## Report to the Future Melbourne (Planning) Committee

**Planning Permit Application: TP-2017-461/A**  
**23-29 Victoria Street, Melbourne**

**8 December 2020**

Figure 21: Excerpt from Planning Response accompanying S.57A Amendment received 22 September 2020 showing original and revised podium design

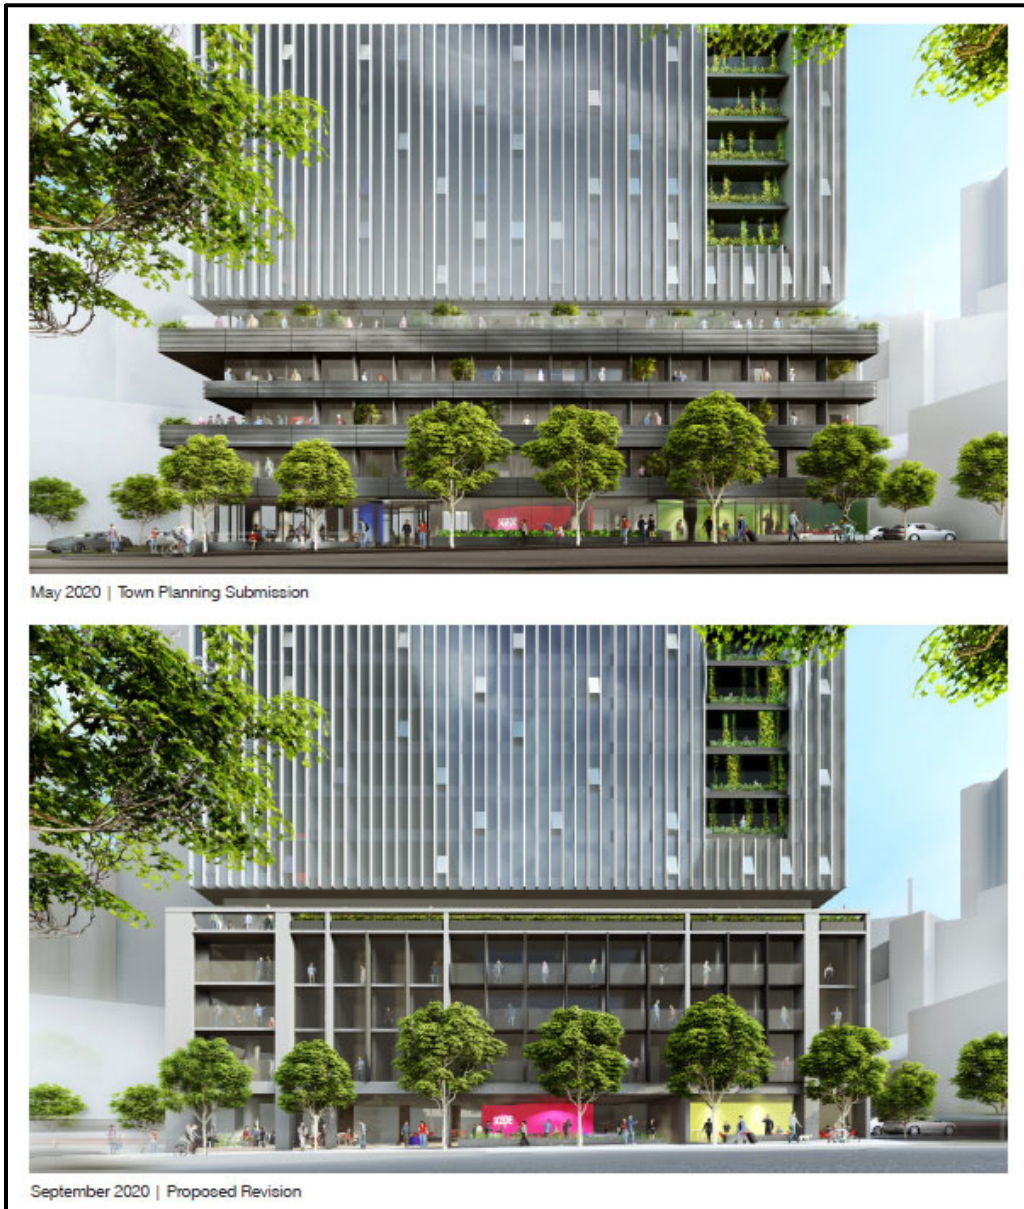
- Discussions (including a meeting) were held following the receipt of Council's Urban Designer's advice, to discuss their concerns relating to the podium design. At the last of these meetings, the project architect advanced a number of potential solutions to address the outstanding concerns related to this element of the development.
- A preferred option was identified at these meetings, and on 22 September 2020 Amendment Application TP-2017-461/A was amended pursuant to S.57A of the *Planning and Environment Act 1987* to formally update the podium design to adopt the preferred option.

Figure 22: Excerpt from endorsed plans (left) and from S.57A amended plans (right) showing Victoria Street elevation

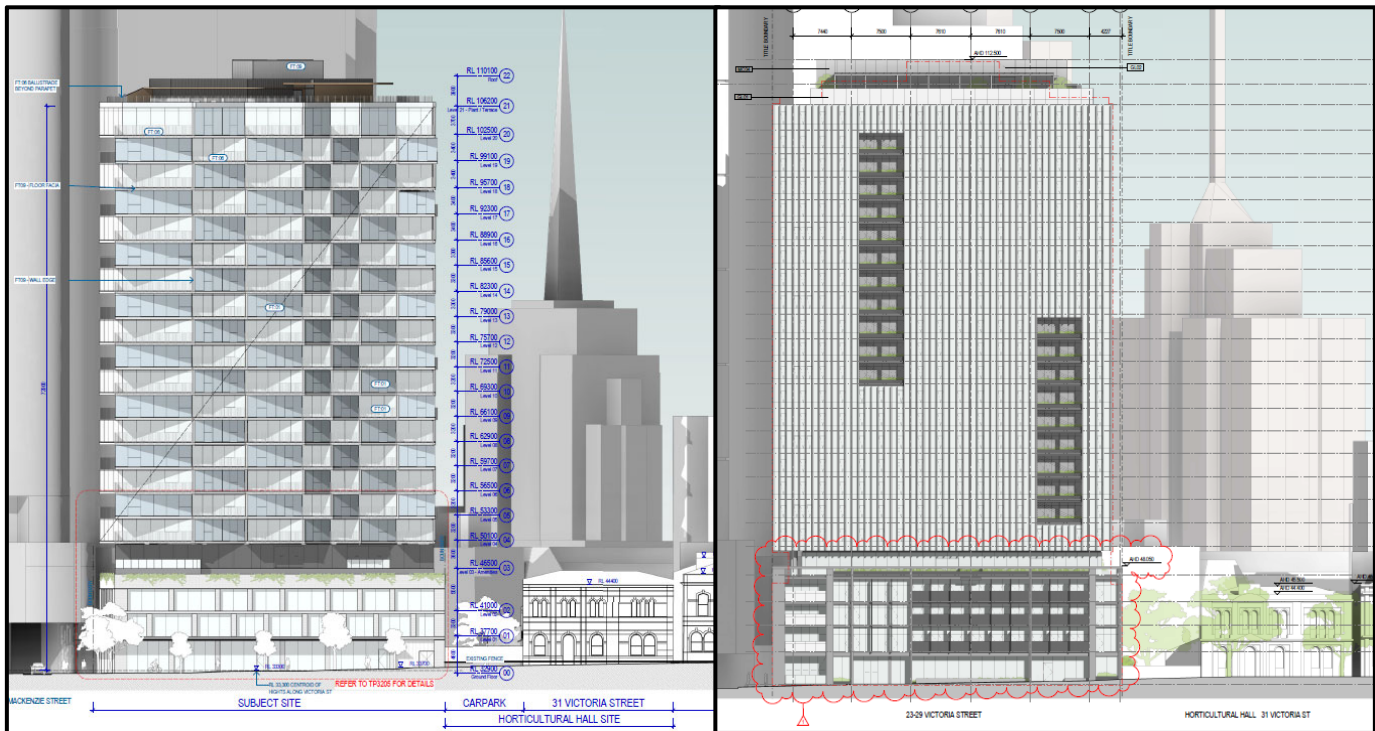
Amendment Application TP-2017-461/A seeks to make minor alterations to the building envelope authorised by Permit TP-2017-461, generally limited to straightening out the tower floorplate and modifying the exterior architectural language and materiality of both the podium and tower.

Diagrams have been provided below to demonstrate the similarity between the presentation of the authorised and proposed tower forms, and the altered tower floorplate layout sought by Application TP-2017-461/A.

It is not considered that the changes sought to scale, height and mass of the development authorised by Permit TP-2017-461/A are of consequence, having regard to requirements of Clause 22.17 Urban Design outside the Capital City Zone.
